Planning Application Number: 25/00990/FUL

Application Address: Land Off Station Road, Bagworth

Table 1: LCC Highways Response Tracker (June 2026)

Appendix 1 – LCC Highways Response dated 9th June 2026

Drawing Title
**Highway Review -
Road Alignment, Turning Heads,
Speed Restraints, Dimensions**

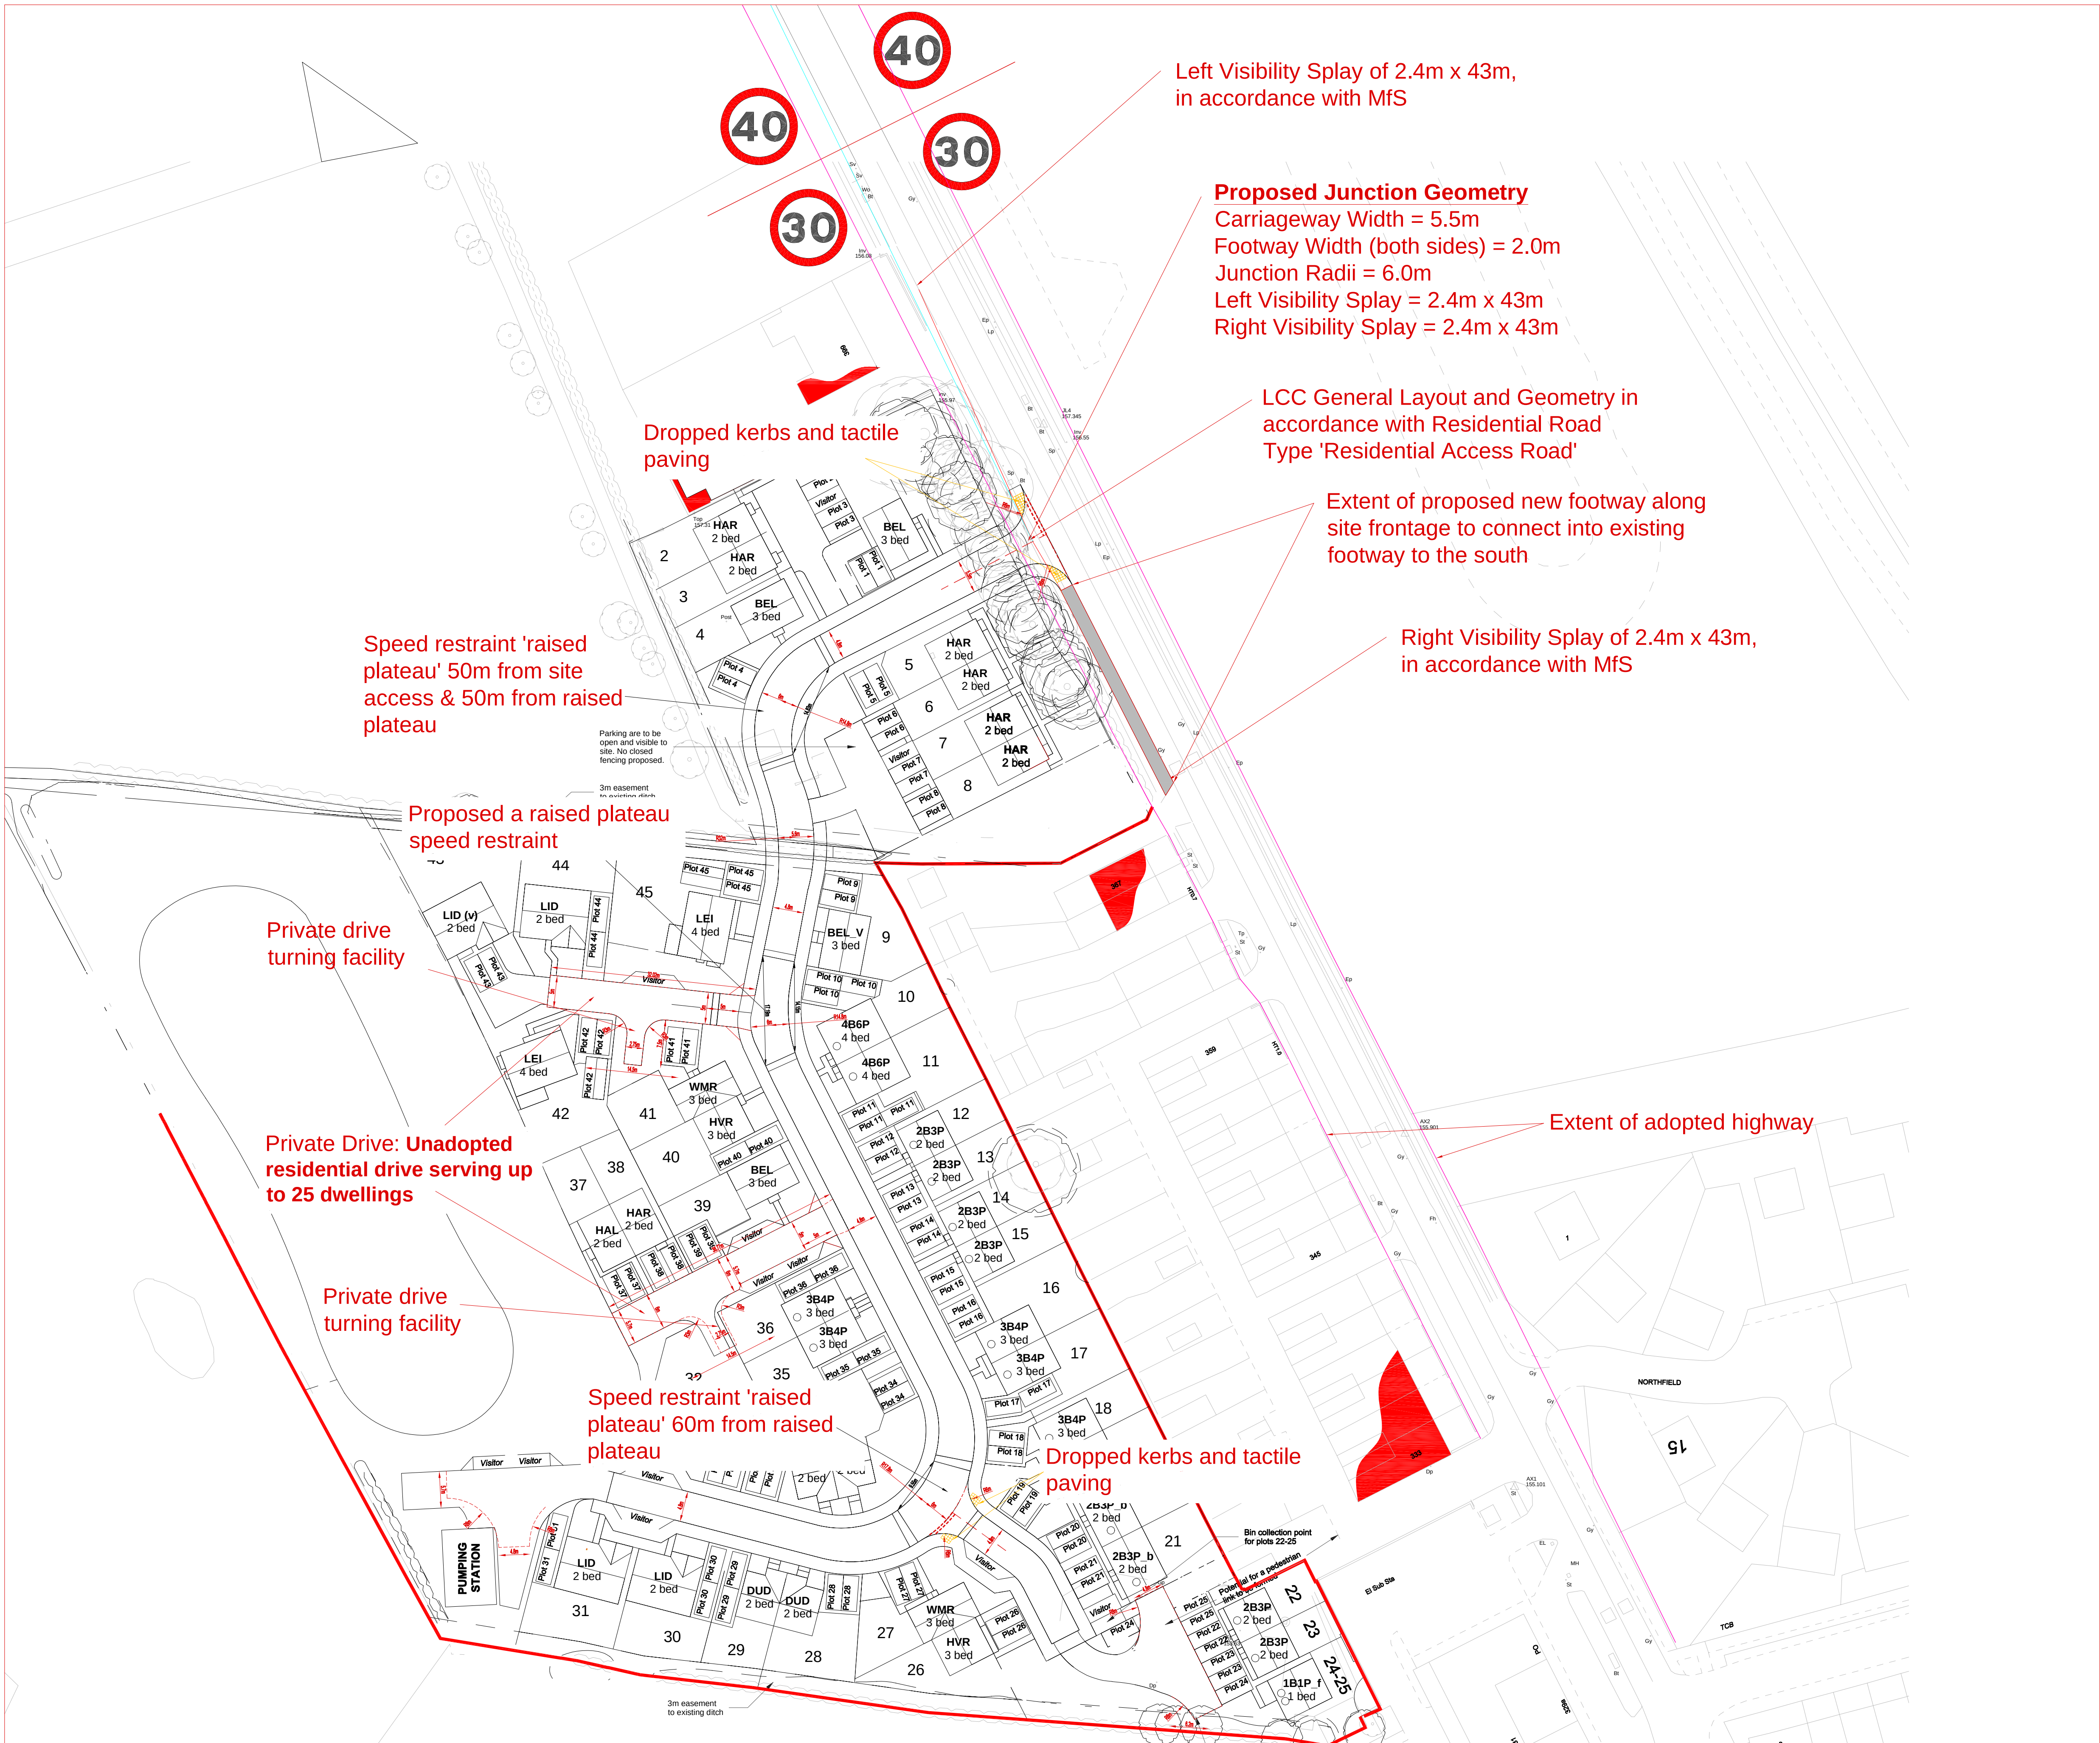
Speed control measures will need to be designed into the road layout. In this instance, the maximum distance between speed control measures, junctions or 90-degree bends is approx.

60m. Further information can be found within [Table 20](#) of the LHDG. The bends o/s plots 4 and 27 do not meet the requirements for a speed control feature as their inner radius exceeds 8m.

Further to the comment above, the minimum plateau length of vertical speed control measures should be 8m, and the ramps should not conflict with the access drives of the dwellings. For further information please see [Figure 31](#) of the LHDG.
